Consultation note regarding first draft of the LRAIC fixed model Paper

DBA started the consultation on the second version of the draft LRAIC fixed model the 20th of March 2014. By the end of the consultation period, the 23th of April 2014, DBA had received consultation responses from Telenor, Telia, Concepy and TDC. DBA has after the end of the consultation period held meetings with Telenor, Telia, Concepy and TDC. DBA has furthermore asked TDC, Telia and Telenor follow up questions and received new information and has organised a conference call with Global Connect.

Figure - A trench

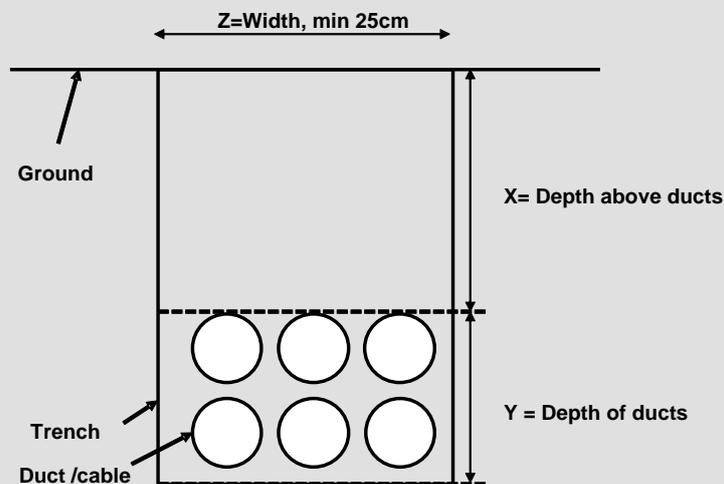
The trench size is determined by using the following rules provided by TDC:

- A trench has a standard height of 60cm and a standard width of 25cm;
- A cable (or duct) must be at least 40cm under the ground (Figure below, $X = 40\text{cm}$);
- The width of the trench must not be filled by more than 60%;
- The height of the trench where cables are located must not be filled by more than 60%.

Figure - Road sections configurations

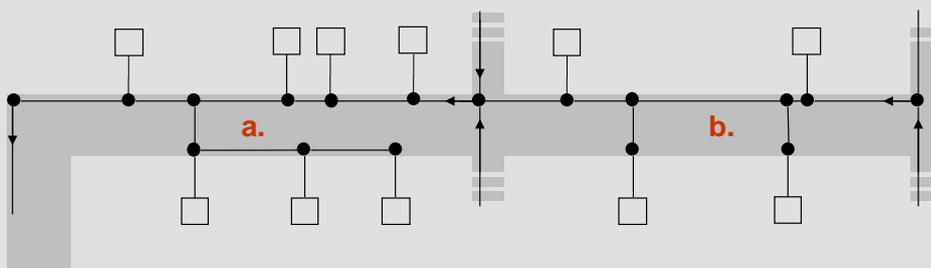
As for the copper network, trench digging is optimised. If digging trenches on both sides is more cost efficient, this option will be chosen. The model documentation describes how trenches are dug on section 3.4.9 extracted below:

When trenches have to be dug on both sides on the road, there are two main configurations for trenches length (see figure below)

Figure 1

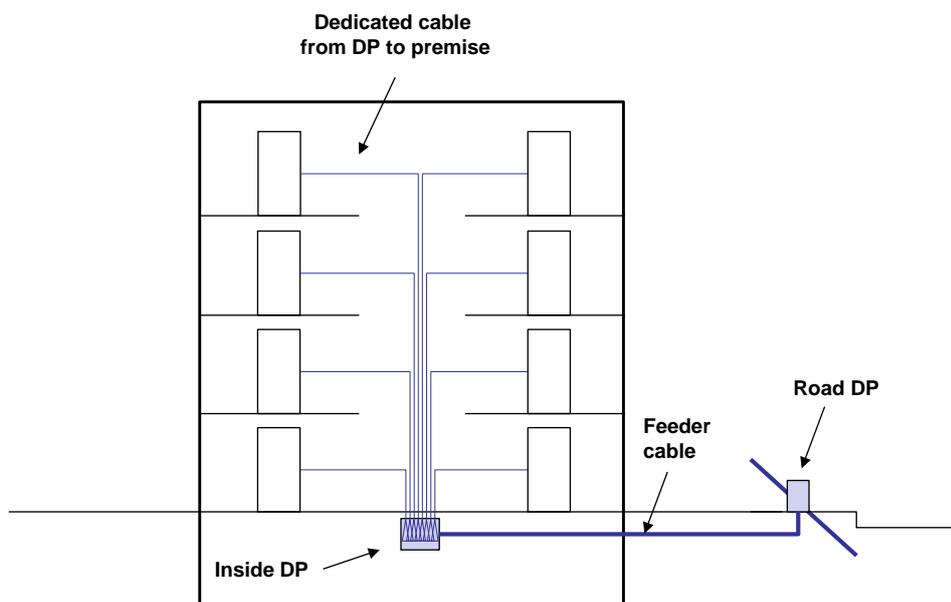
A distribution point is installed in the basement of the building, it is fed by a single cable coming from the street.

A dedicated cable is installed from this distribution point up to each flat. The length of each cable calculated based on the height per floor (3.5m), the number of floors and the distance between the staircase and the apartment (4m) (See Fig. 1).

Figure 2

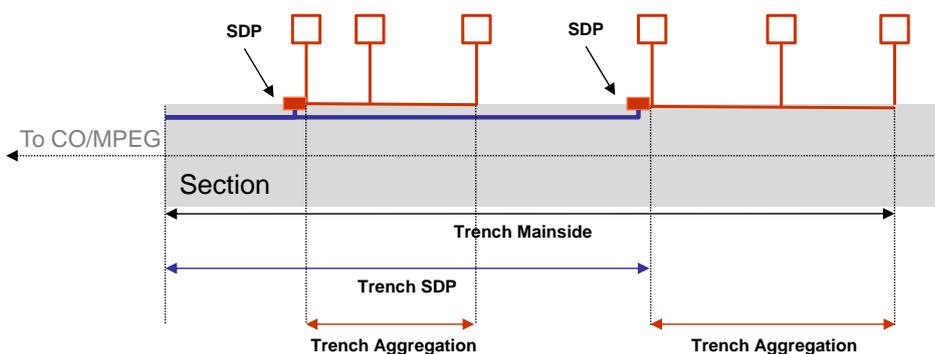
- If the section does not aggregate any section that has a SDP and has at least a SDP, if the section holds a PDP, the max length between the first and the last SDP and between the SDP and the PDP is used. If the section does not holds a PDP, the length between the last SDP and the beginning of the section is used (See Fig. 3 below).

- If the section does not aggregate any section that has a SDP and no SDP is installed on the section, 0 is used for the SDP length.
- For the aggregation length, the length of trenches used between the premises and SDPs is used (See Fig. 3 below).

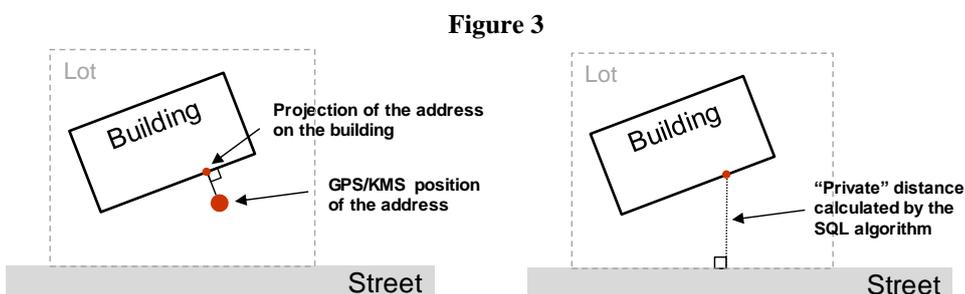
TDC states that the row 'Length_To_Section' is the distance from the road segment to the front of the house. The average distance is app. 13,8 meter, which is approximate the distance called 'BO_BP' in the previous

model (BO_BP=14,1 meter, see appendix B in the model documentation of the previous model). The cable is however not necessarily drilled through the wall in the front of the house. This can as well be on the sides or on the back of the house. In the previous model this distance was in average 5,7 meters making the total distance 19,8 meter. The sample size in the previous model was large. TDC therefore does not believe that the deviation is caused by sampling errors.

TDC requests DBA to clarify if the calculation failure with regard to the distance from road to premises entry point lies in the previous or draft model.

DBA considers that this point has been addressed in the previous round of the consultation, when a non-linear factor for the private property part of 120% has been introduced.

Figure 4

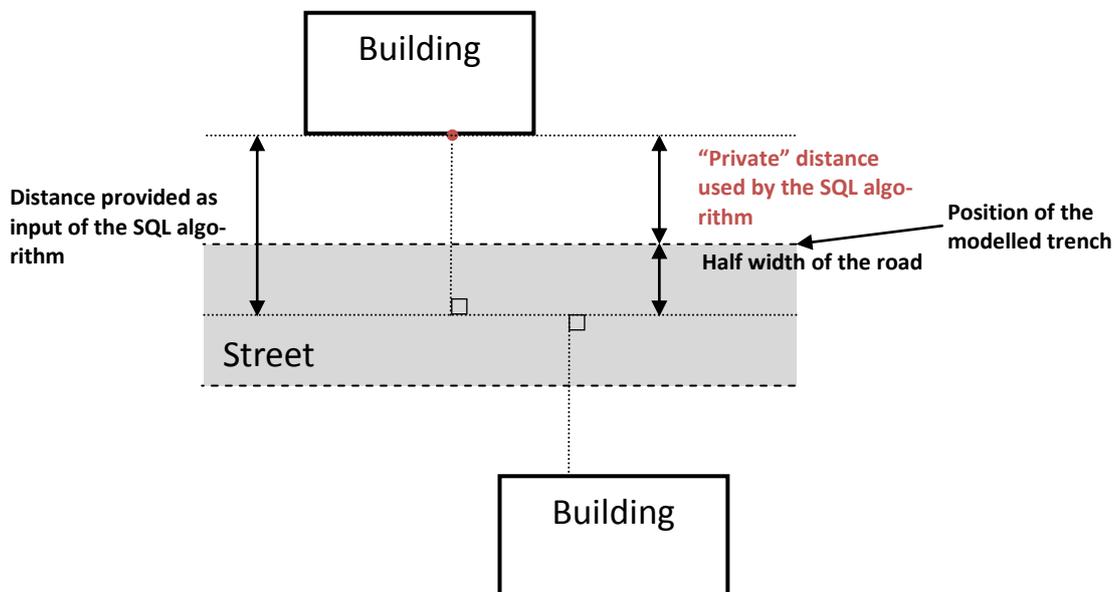
- The trench on a given side is considered to be positioned at half of the road width to the middle of the road, and
- the length between the wall of the building and the trench is the length between the wall and the middle of the road, minus half of the road width.

DBA considers that no additional distance has to be added.

Figure 5

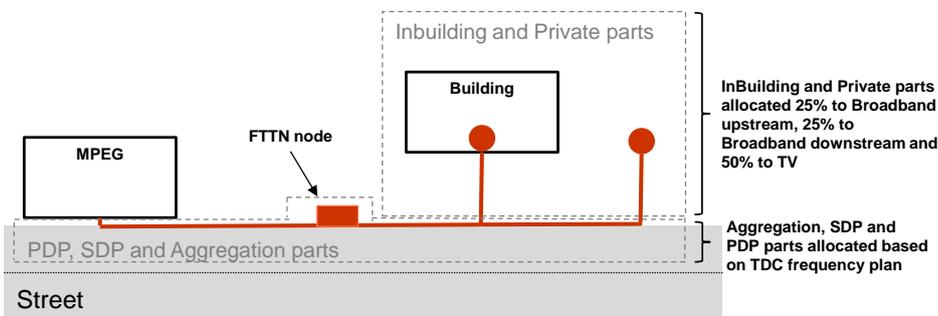
DBA will adjust the model in order to allocate the costs from the final distribution point to the MPEG station based on the frequency plan of Yousee.

The 'Inbuilding' and 'Private' parts will be allocated 25% to broadband upstream, 25% to broadband downstream and 50% to TV access (see Fig. 5 below).
